Information Only Service Note

N6700B - Low-Profile Modular Power System

Serial Numbers: Below "MY54004000" (blue/white). "MY54004000/MY999999999" (amber)

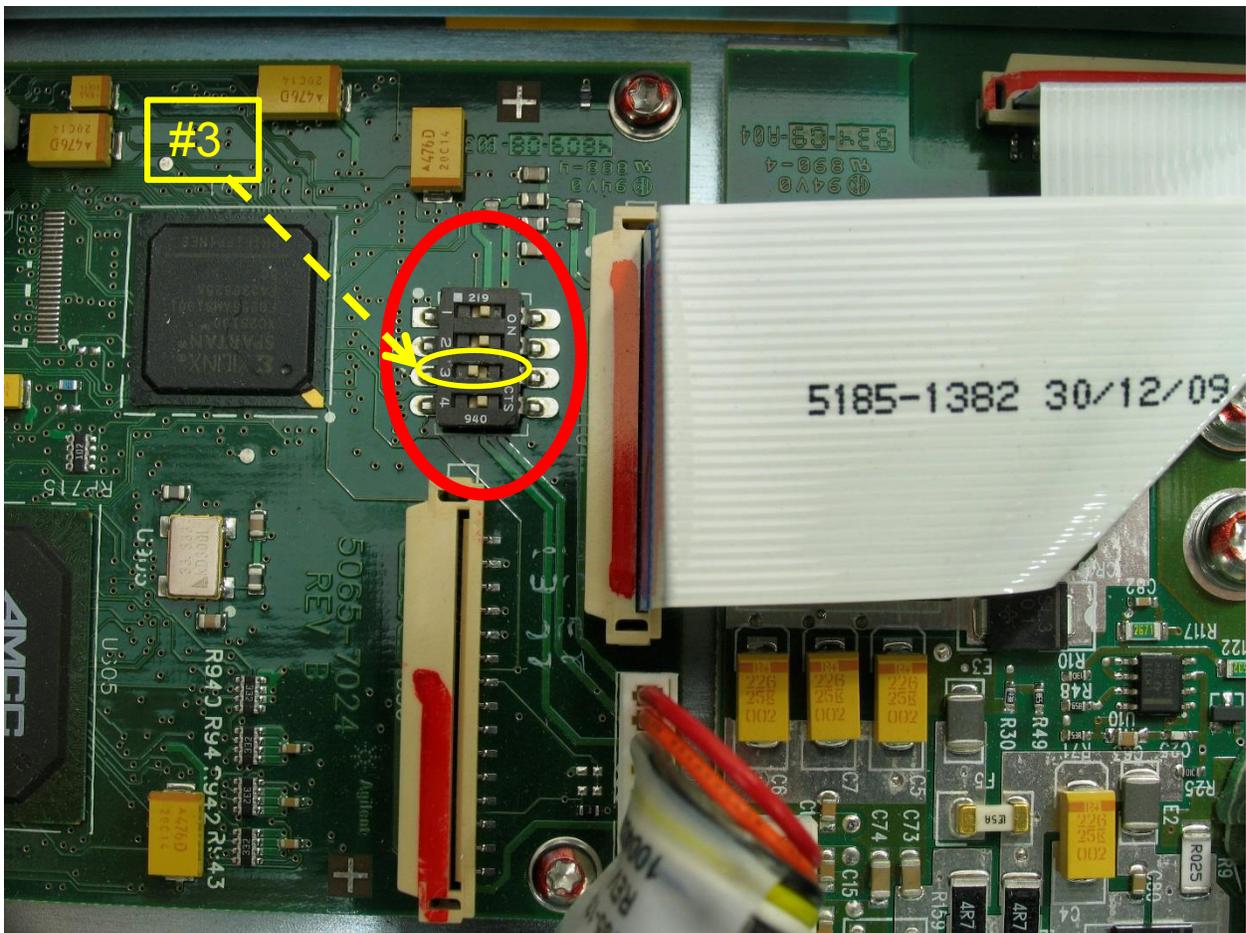
The Situation – Blue/white Front Panel LCD Display (below) has been obsoleted.

LCD (blue/white display assembly, p/n 2090-1031) has been discontinued by vendor. Replacement assembly (pictured later) is p/n 5067-6532 (amber in color). Difference in color is unfortunate, but cannot be altered.

1) New LCD display (5067-6532) is a mechanical & functional “drop-in” replacement for the original.

2) 4-pole dip switch on PPMC PCA must have pole #3 repositioned to “off” as shown below:

3) Instrument firmware must be version D.04.01 or newer for proper operation of this display.
